# ST. TAMMANY PARISH PLANNING COMMISSION MEETING 6:00PM – TUESDAY, JULY 9, 2019 ST. TAMMANY PARISH GOVERNMENT COMPLEX PARISH COUNCIL CHAMBERS 21490 KOOP DRIVE, MANDEVILLE, LOUISIANA

# MINOR SUBDIVISION STAFF ANALYSIS REPORT (As of July 1<sup>st</sup>, 2019)

# PRELIMINARY SUBDIVISION STAFF ANALYSIS REPORT (As of July 2, 2019)

# FINAL SUBDIVISION STAFF ANALYSIS REPORT (As July 2, 2019)

Attached is the drainage plan showing these improvements and a Vicinity Map.

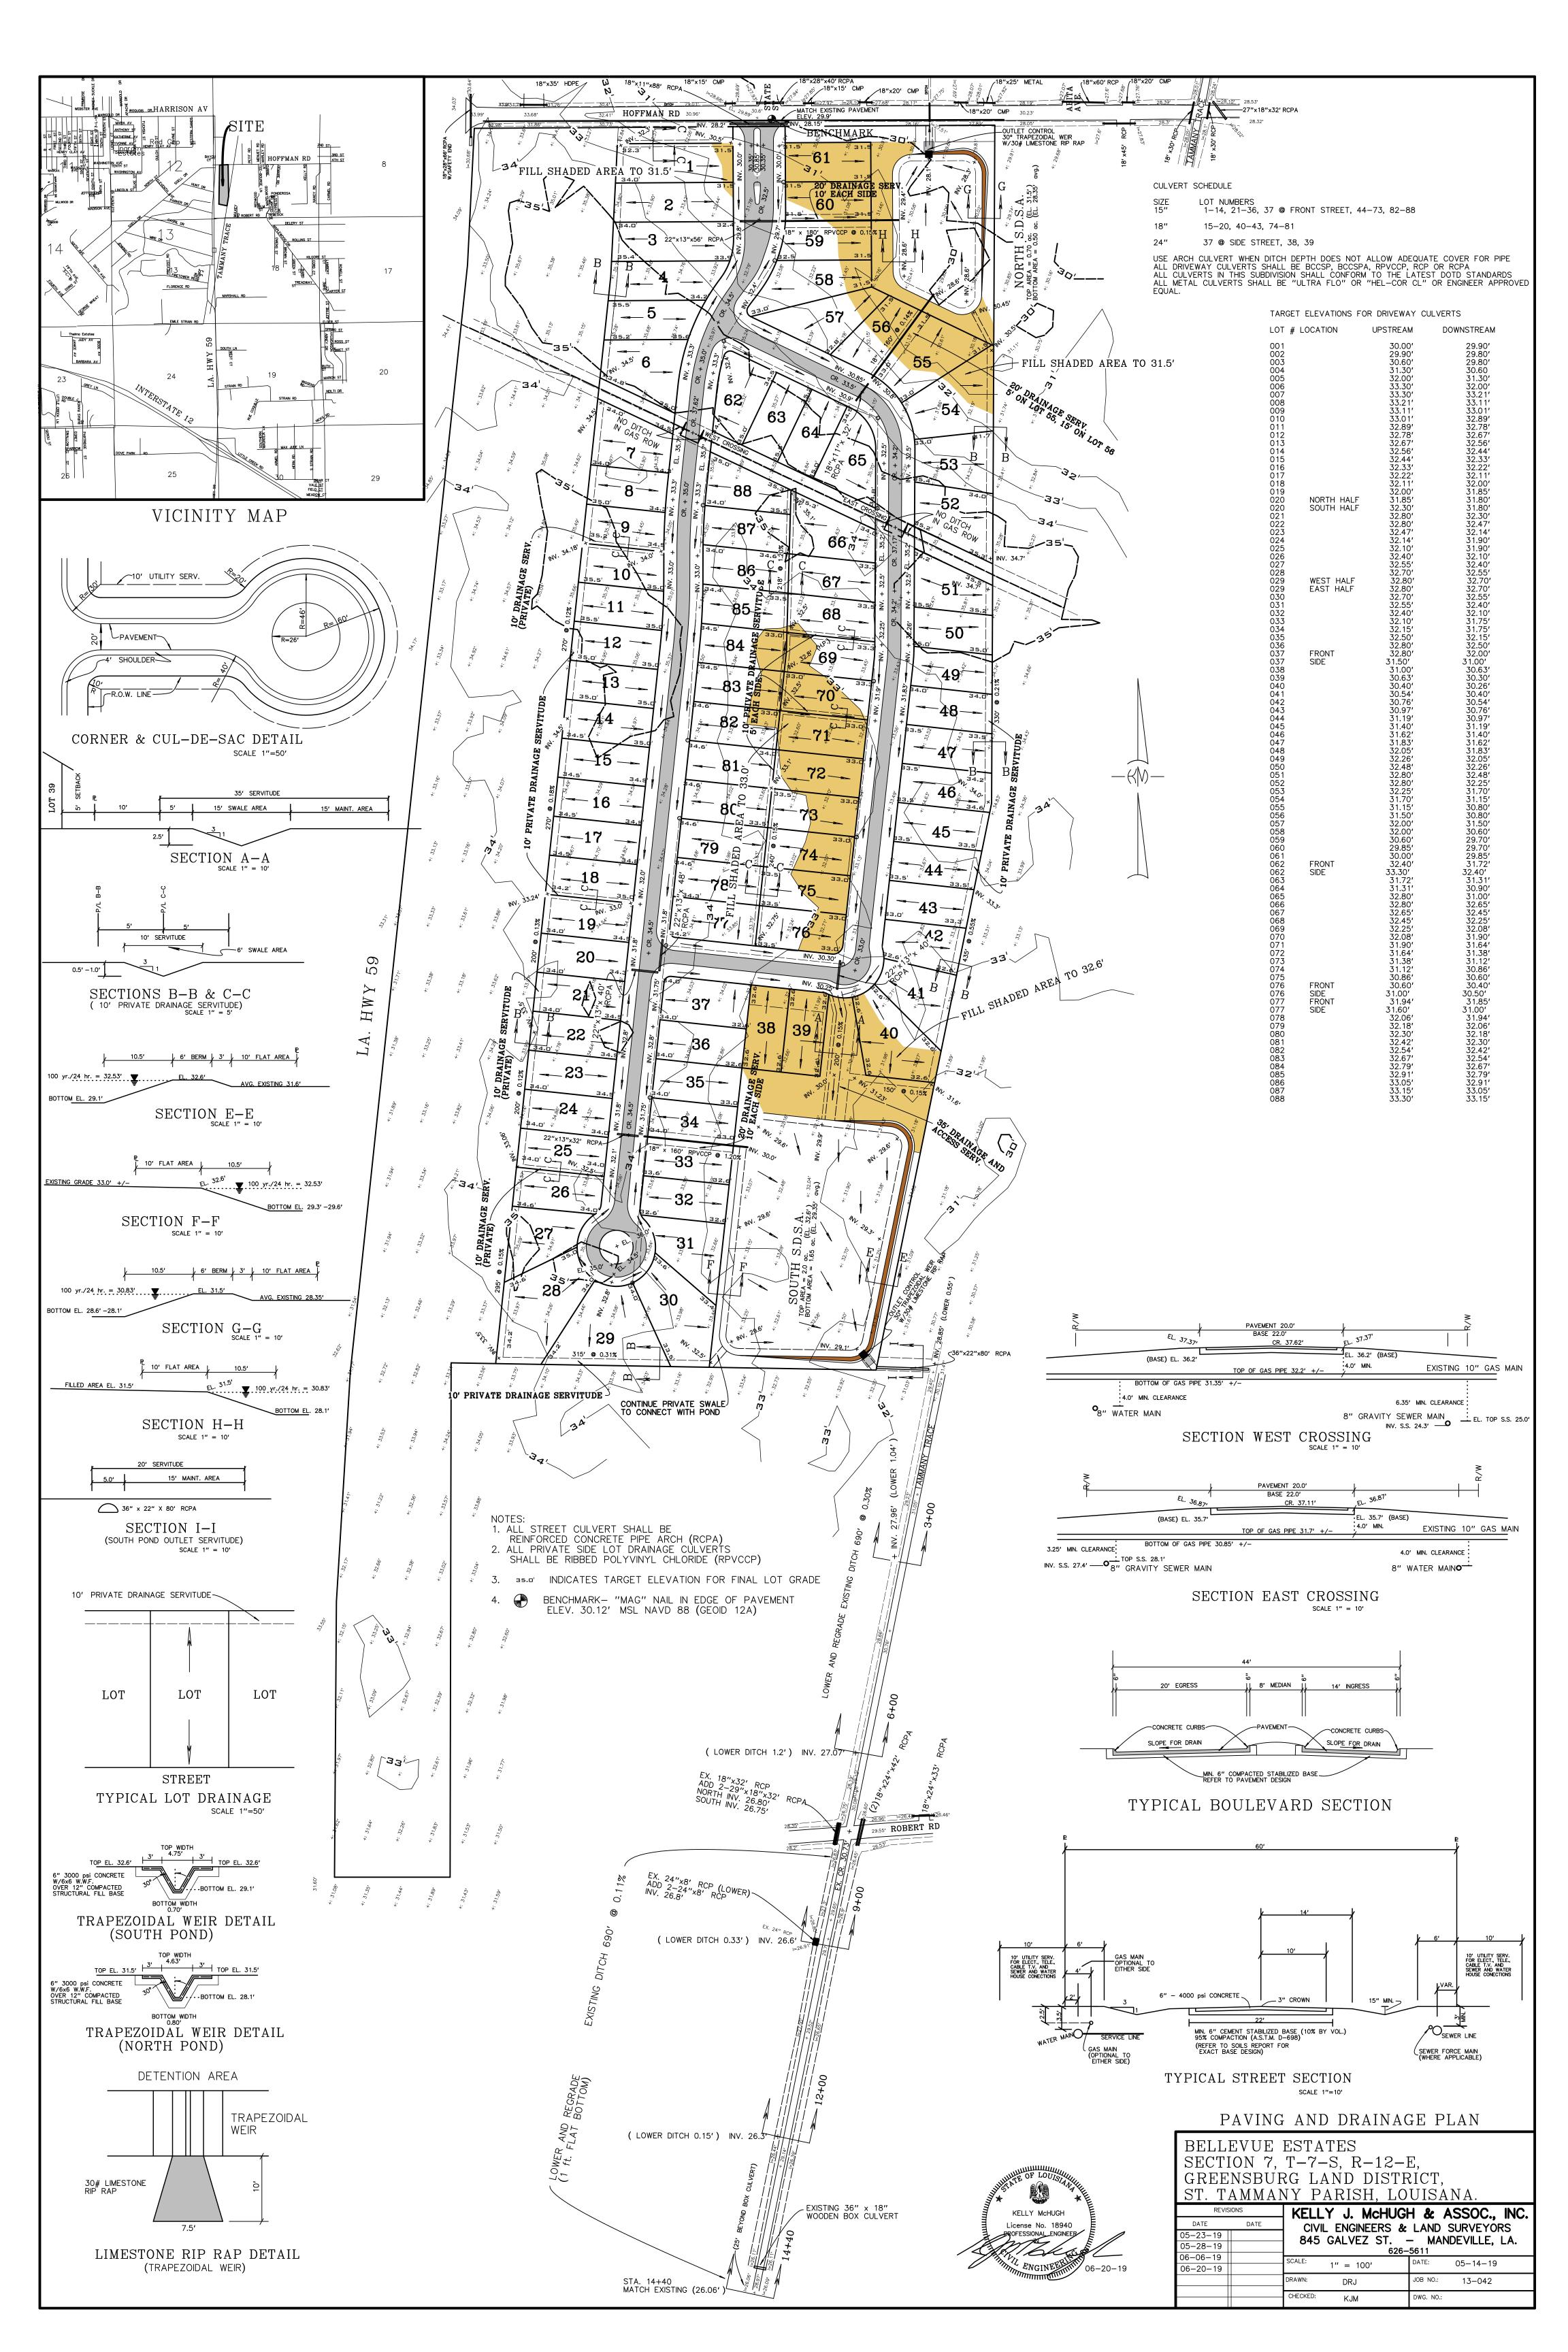
The drainage modifications proposed in this request will result in significant impacts to the Tammany Trace. These impacts include:

- A significant increase in the volume of water from this development being directed to the Trace Right of Way from a single point source instead of sheet flow per the existing condition. This could potentially cause or exacerbate local drainage issues in the vicinity.
- The permanent removal of an approximate 20' wide by 80' long section of Trace buffer screen needed to install the 36" subsurface drainage pipe.

- The land clearing of additional trees needed to accommodate the proposed ditch modifications along a 1540 ft. portion of the Tammany Trace Right of Way.
- Two (2) culverts being installed in addition to each existing culvert at the intersection of Robert Road and at the intersection of the horse trail crossing approximately 150 ft. south of Robert Road.

The proposed plan does not meet the minimum requirements listed in Section 30-372(d)(4) above.

The Staff is not opposed to granting access to the Tammany Trace Right of Way to utilize the ditches for drainage, however, we do have concerns with the scope of the drainage modifications being currently proposed. We do not want this development or future developments to increase the volume or speed of flow of the Tammany Trace ditches. It is recommended that the drainage calculations match existing conditions of volume and flow within Tammany Trace ditches.

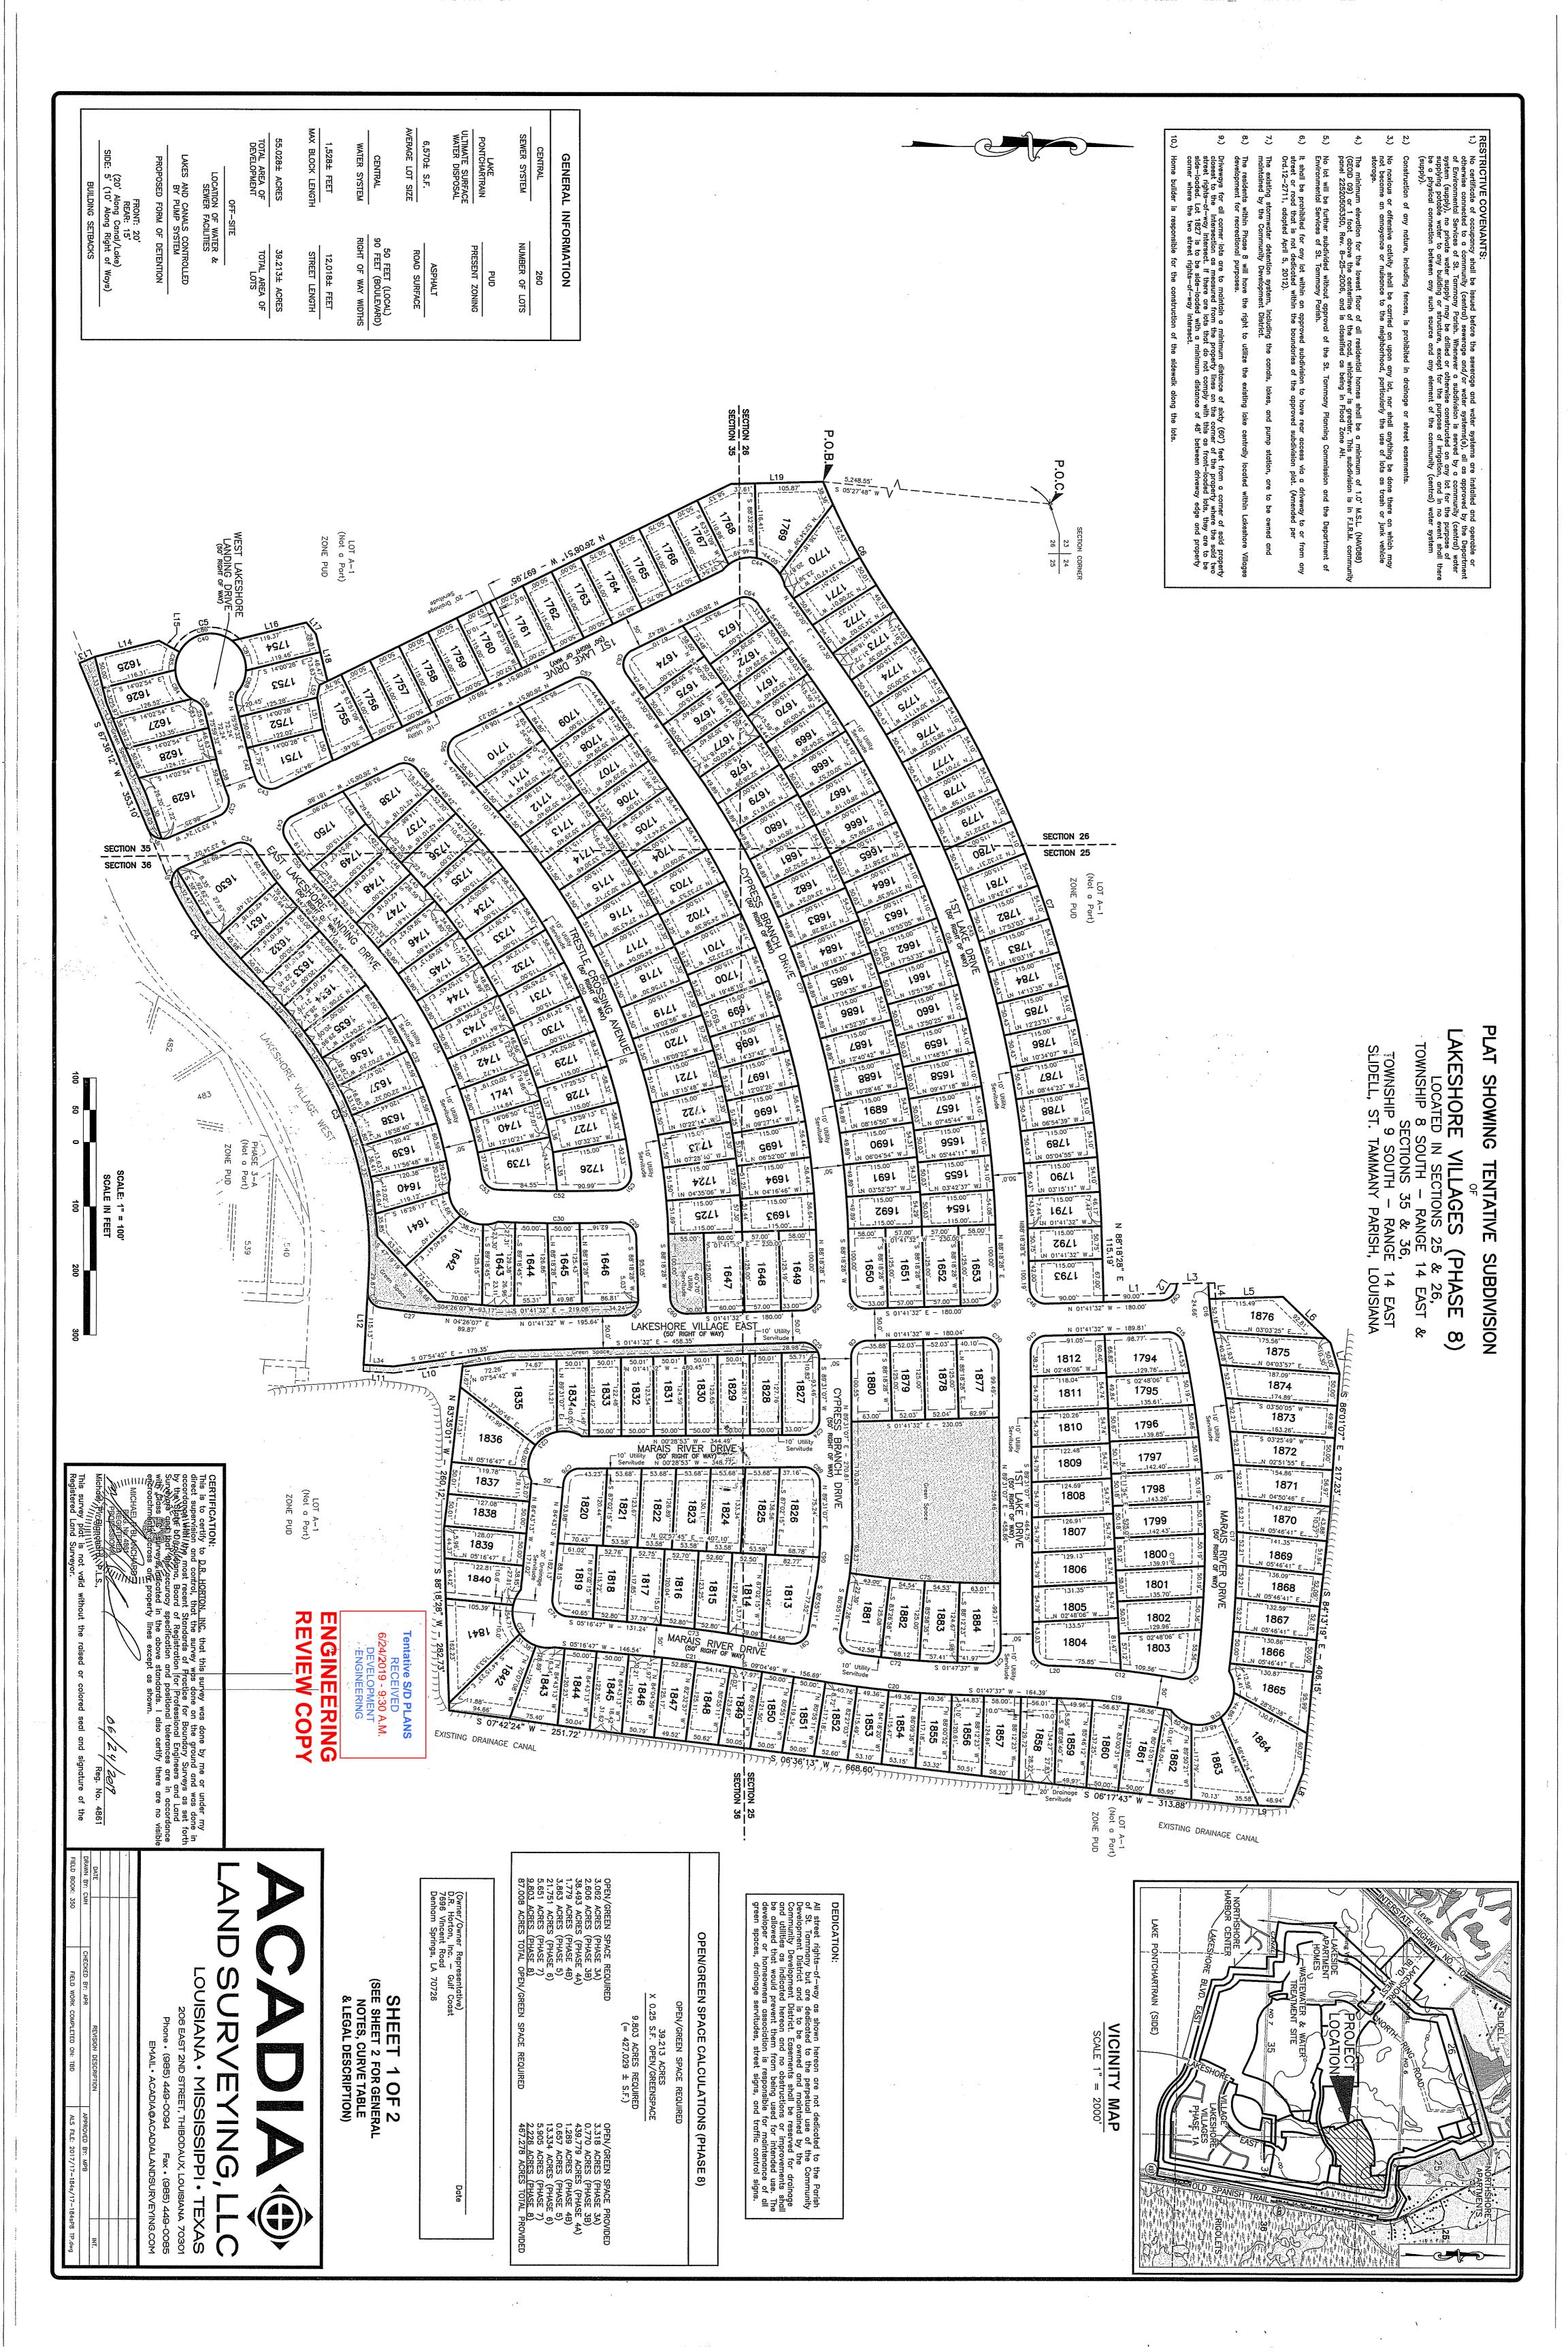
- 1. An updated Traffic Impact Analysis including Phase 8 of this development must be submitted and approved by St. Tammany Parish and LADOTD.
- 2. Approval from 911 addressing for all road names and addresses within Phase 8 will need to be provided when submitting for Preliminary Approval.
- 3. A waiver of the minimum driveway requirement is being requested for lot #1827 to reduce the required distance of sixty (60) feet to forty-eight (48) feet. In order to approve this waiver request a 2/3rds majority vote of the full membership of the commission (8 members) is needed, pursuant to Section 125-224 Waiver of Regulations, of Chapter 125 Subdivision Regulations.

Phase 8 Waiver Exhibit

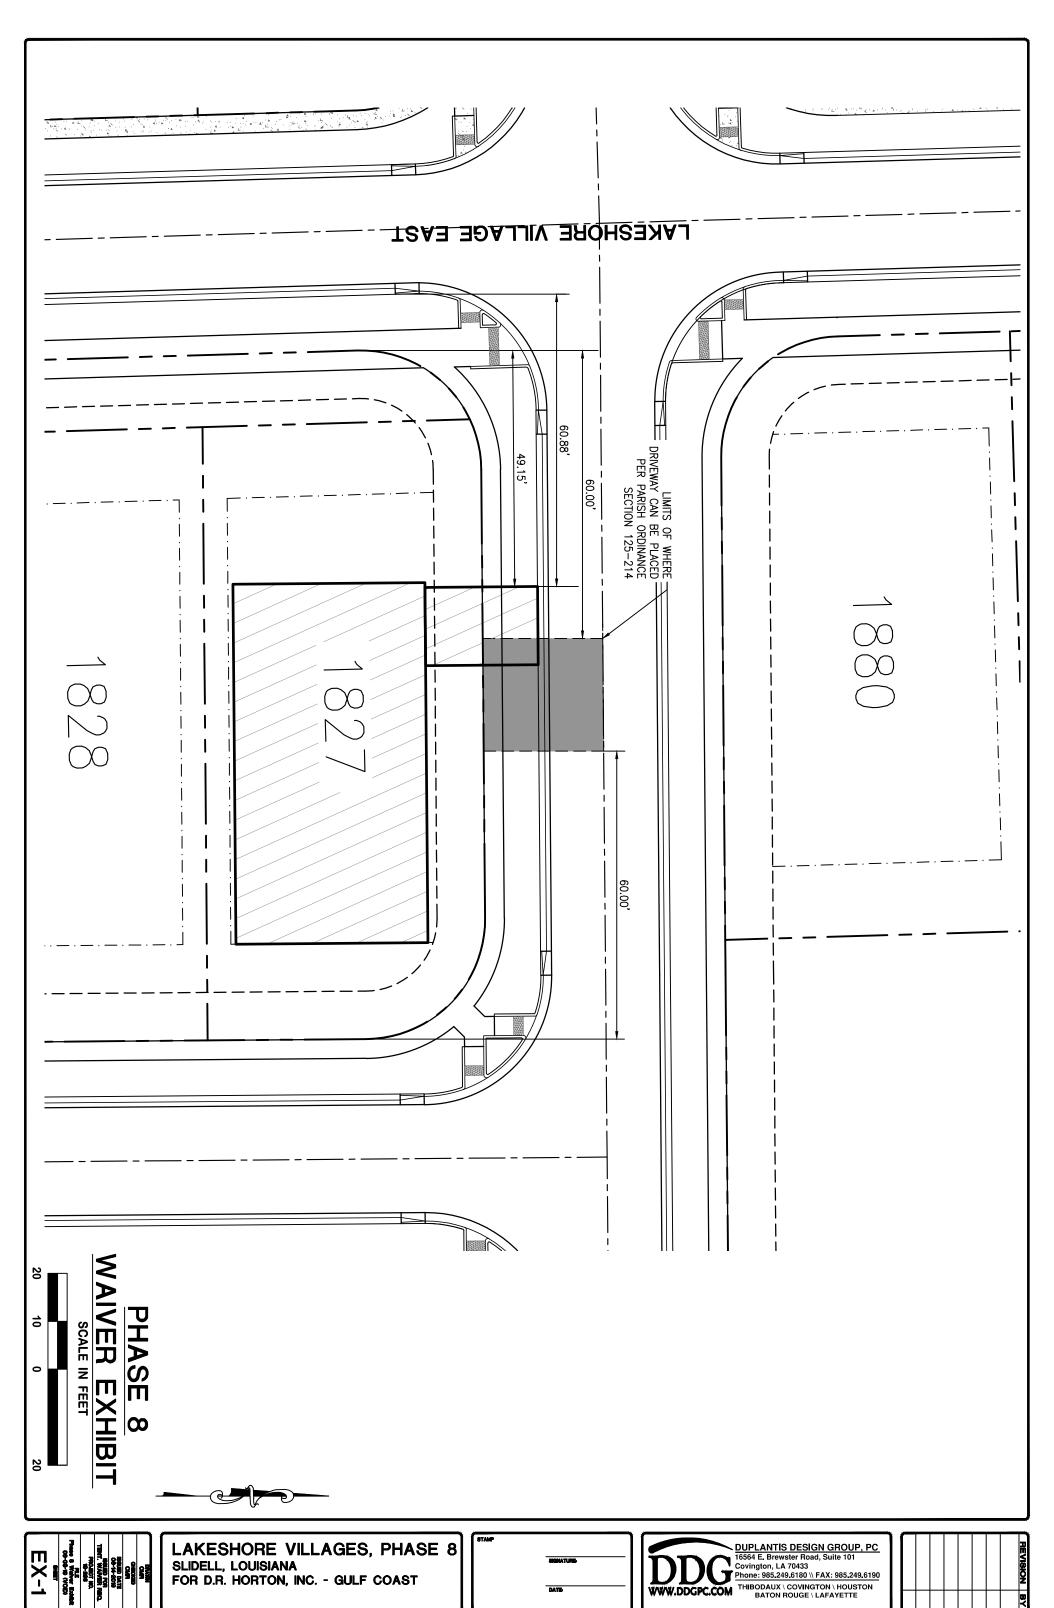
The developer would like to request a waiver pertaining to Lakeshore Villages Phase 8. The Subdivision Regulations Chapter 125 Section 214 states, "Driveways on corner lots shall not be located any closer than sixty (60') feet from a corner of said property closest to the intersection as measured from the property lines on the corner of the property where the said two street rights-of-way intersect." The developer is requesting a waiver to reduce the distance between the right-of-way intersection and driveway from 60' to 48' for Lot 1827. That distance still allows for a 60' clearance between the driveway and where the back of curb would be. If any of the remaining corner lots do not meet the 60' clearance from the adjacent intersecting rights-of-way to the driveway, then those lots will be side-loaded.
